**Subject: ITB #1901-B: Lagoon Dredging
Addendum #3**

ITB #1901-B: Lagoon Dredging

CROSSTOWN WATER TREATMENT PLANT, 3500 TDK BLVD, PEACHTREE CITY GA, 30269

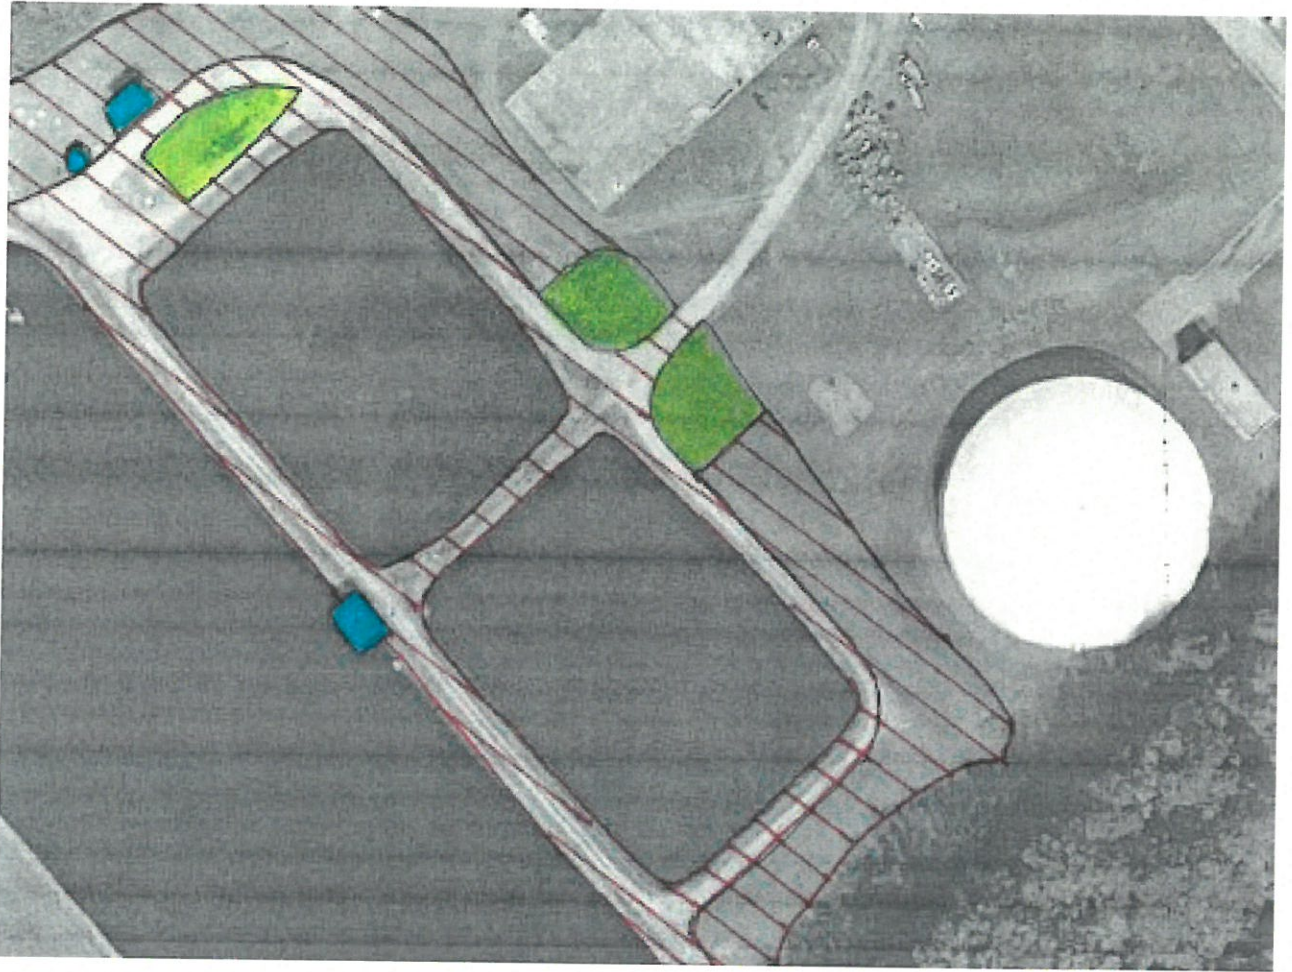
6. **Where can we set up to de-water the sludge?**

9. **Where can we get utility water access?**

- 12. Is there anywhere we can't set up?**
Please see the attached drawings. Attachments 1 & 2.
- 13. May we work at night?**
Yes. Normal day shift hours are 7 am – 7 pm. If you plan to work outside the normal day shift hours, you shall give the Plant Manager 24 hour prior notice.

Please see the attached drawings. Attachments 1 & 2.

At each location there is 480V, 60HZ, 3 phase, 100A supply available. (see attachment)

At Crosstown there is an accessible yard hydrant by the North Lagoon. Lagoon water is also an acceptable water source that can be recycled back to the Lagoons.

NOTE: WATER FROM THE LAGOONS MAY BE USED FOR DREDGING EQUIPMENT AND WATER MAY BE DRAINED BACK TO THE LAGOONS AS RECYCLABLE WATER SOURCE.
